CITY OF CODY
PLANNING, ZONING AND ADJUSTMENT BOARD
TUESDAY, AUGUST 14, 2012
CITY HALL COUNCIL CHAMBERS @ 12:00 NOON

MEETING DATE:	AUGUST 14, 2012	TYPE OF ACTION NEEDED	
AGENDA ITEM:		P&Z BOARD APPROVAL:	X
SUBJECT:	SITE PLAN REVIEW: SHOP AND WAREHOUSE FOR McCLURE CUSTOM BUILDERS. SPR 2012-30	RECOMMENDATION TO COUNCIL:	
PREPARED BY:	TODD STOWELL, CITY PLANNER	DISCUSSION ONLY:

MEETING DATE:	AUGUST 14, 2012	TYPE OF ACTION NEEDED	
AGENDA ITEM:		P&Z BOARD APPROVAL:	X
SUBJECT:	PAT O'HARA BREWING CO., DOWNTOWN ARCHITECTURAL DISTRICT REVIEW SPR 2012-31	RECOMMENDATION TO COUNCIL:	
PREPARED BY:	TODD STOWELL, CITY PLANNER	DISCUSSION ONLY:

MEETING DATE:	AUGUST 14, 2012	TYPE OF ACTION NEEDED	
AGENDA ITEM:		P&Z BOARD APPROVAL:	X
SUBJECT:	SITE PLAN REVIEW: JOE'S AUTO SPR 2012-34	RECOMMENDATION TO COUNCIL:	
PREPARED BY:	TODD STOWELL, CITY PLANNER	DISCUSSION ONLY:

NEW FLOOR PLAN
1/8"=1'-0"

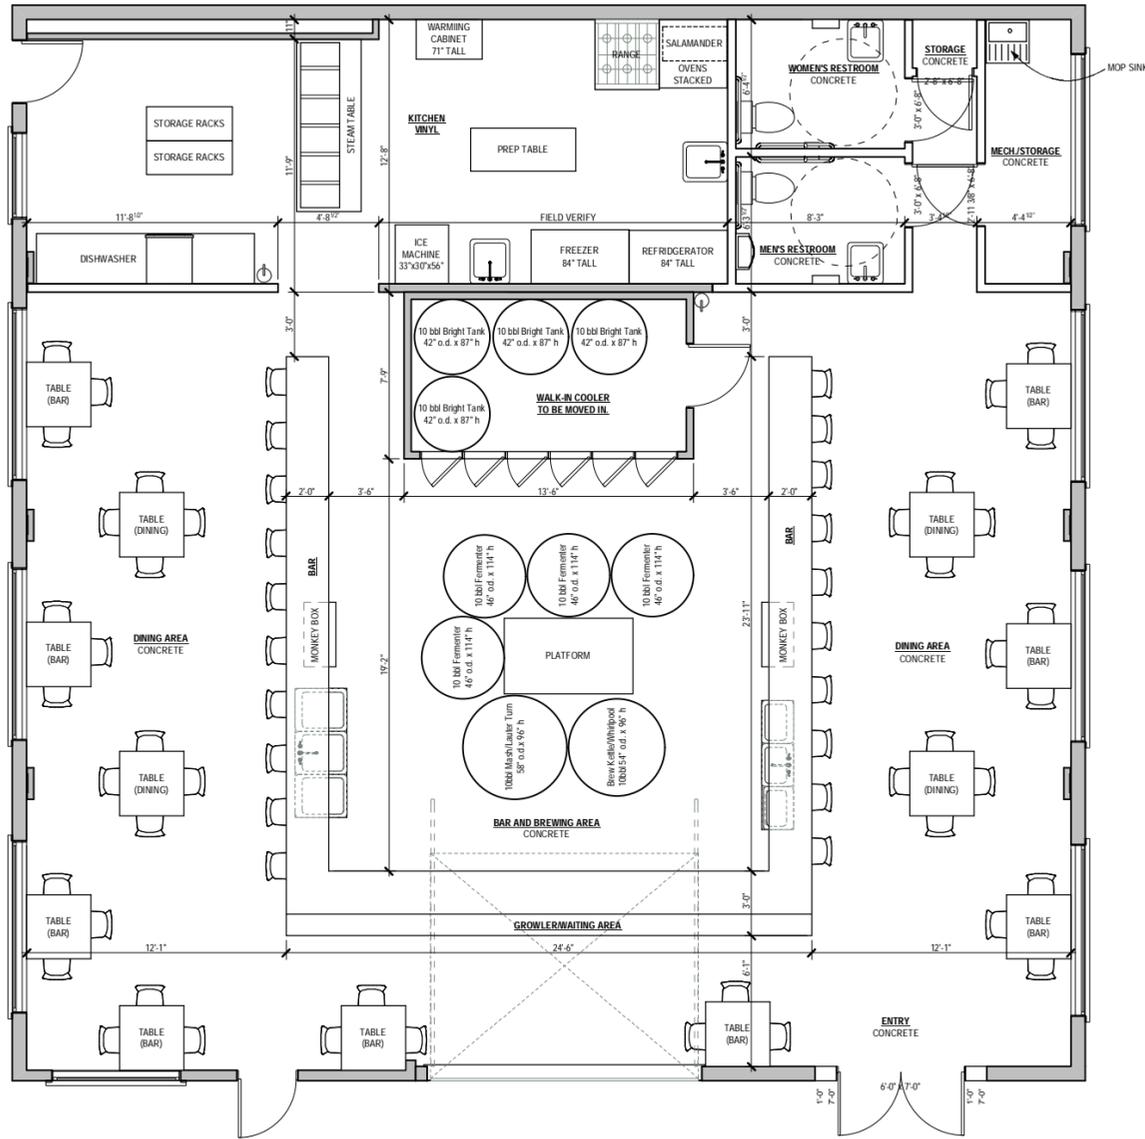
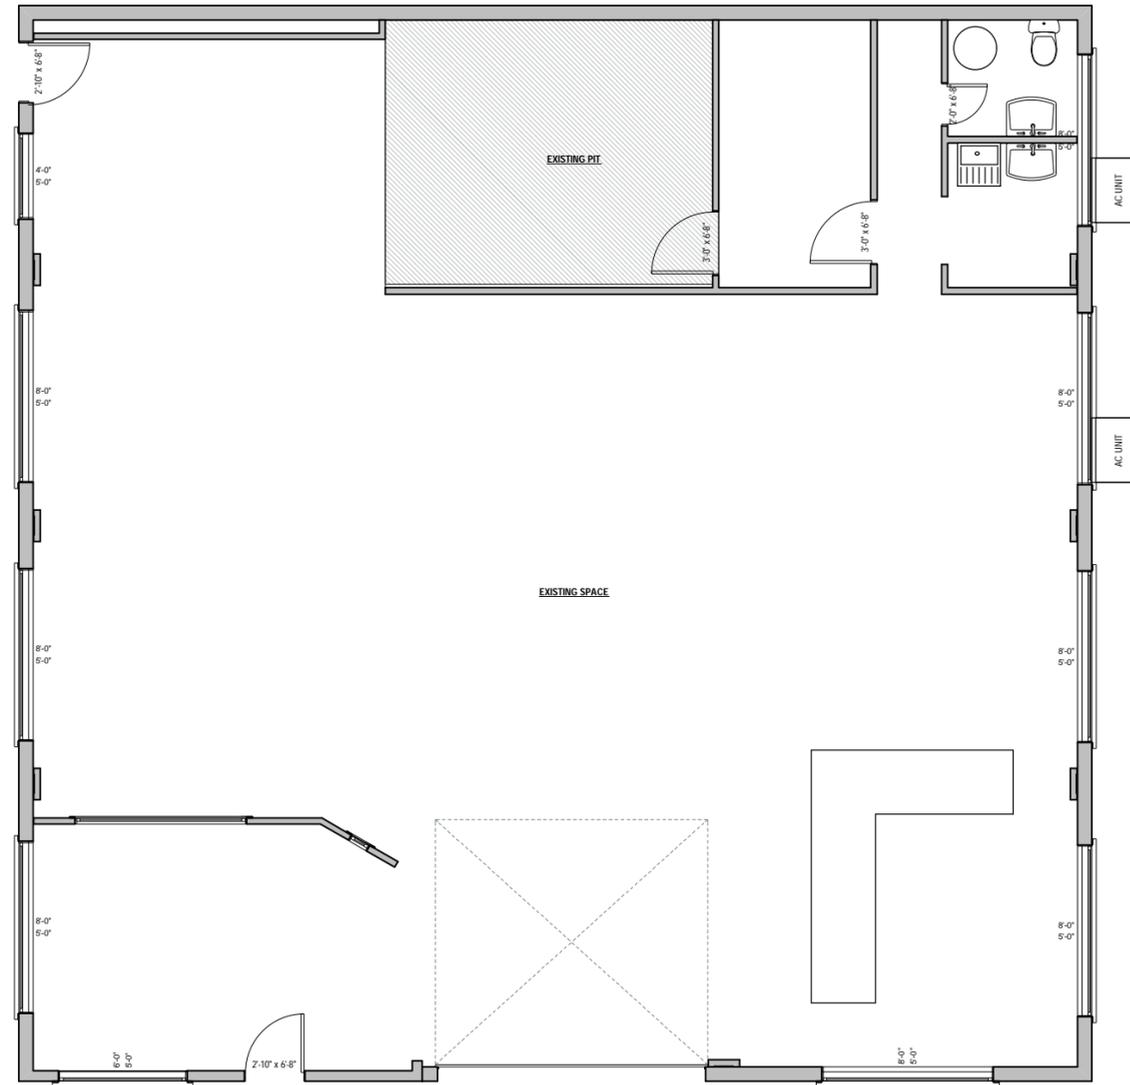
A double doorway will replace an existing window location, as shown on the attached plans, in order to meet building/fire code exit requirements. Details of the new doorway are not included in the application materials, but have been verbally described as a commercial, full-glass, double-entry door. They will also attempt to use existing brick to extend the brick trim down to the bottom threshold of the doorway to maintain architectural integrity.

SITE PLAN
1/16"=1'-0"

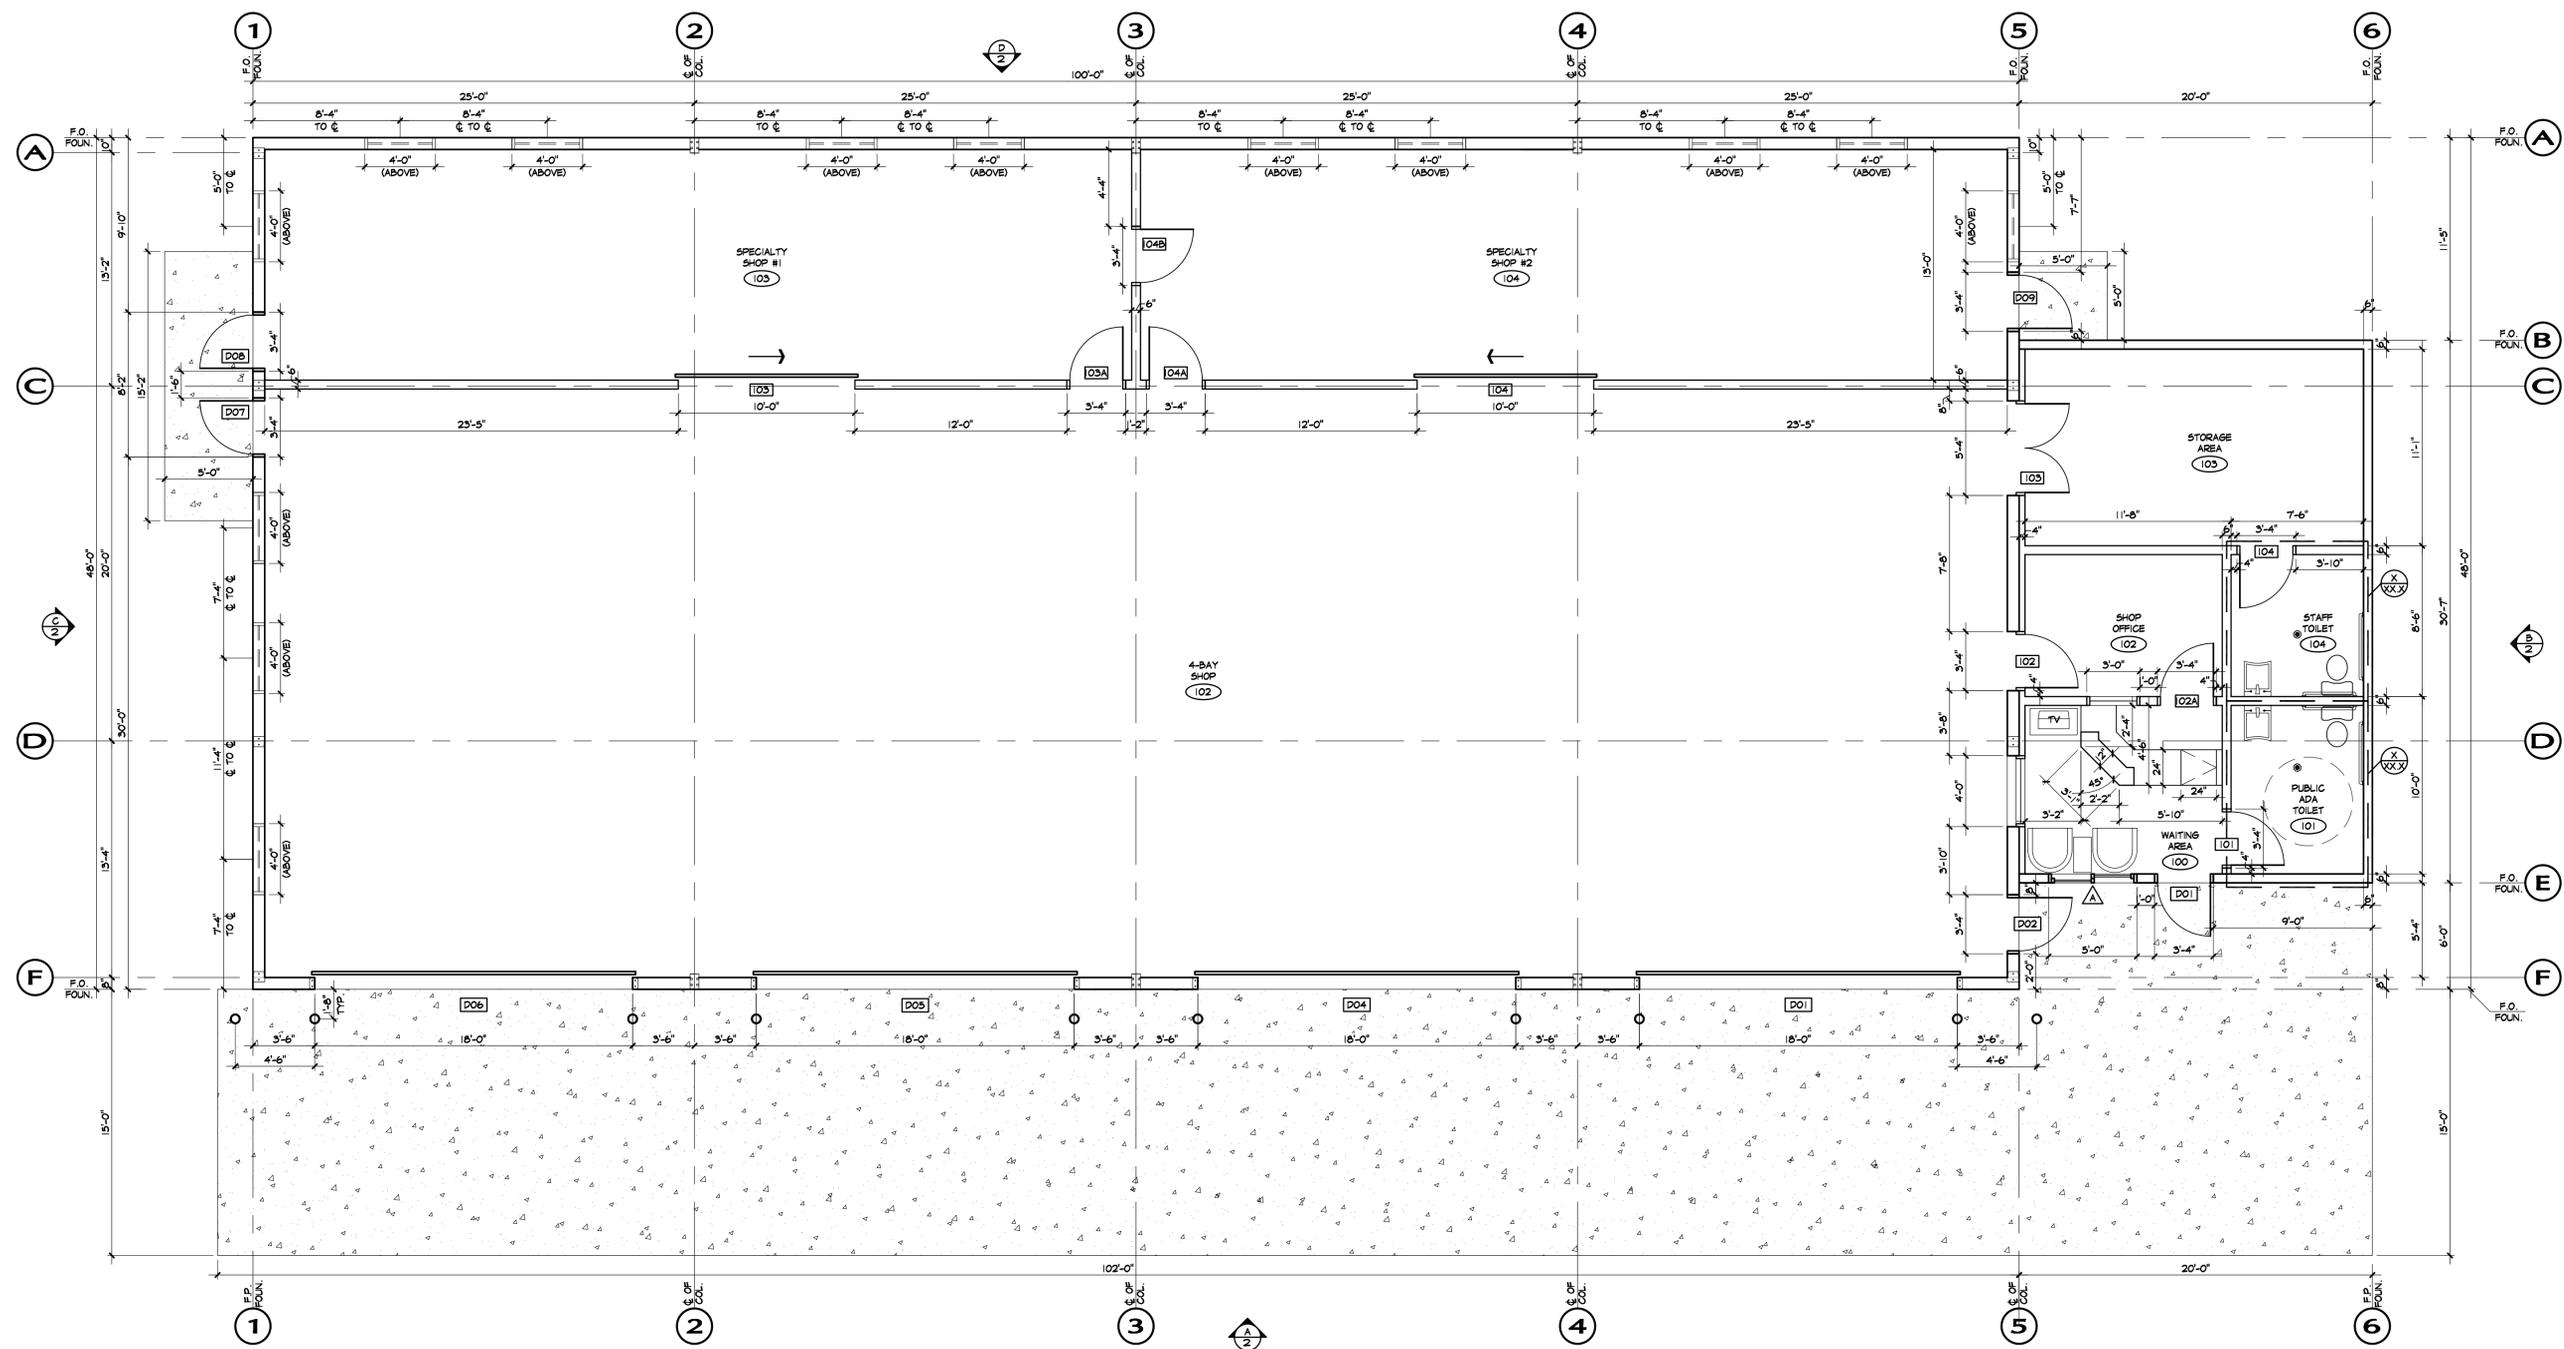
An engineered storm water plan has been prepared to address runoff according to the City's storm water policy manual. The plan includes a 100-foot long ditch along the west property line and a two-foot deep drainage swale on the east side of the property. The facilities are sized to retain the design storm with no percolation assumed. This is good, since part of the east drainage swale would see compaction with the parking proposed on it.

The location of the water and gas lines need to be slightly modified, so that adequate cover is provided—they are currently shown as being under the drainage swale, which may not provide adequate cover and is not allowed for the water line due to potential contamination issues.

1. That more detailed plans for the ADA parking space, unloading area, and pathway to the front door be provided, which meet current ADA standards.
2. That the size and connection details for the oil/water separator be provided with the building permit application.

6. That an irrigation system be installed for the landscaping.
7. That the water line and gas line locations be modified to be outside the storm water swale.
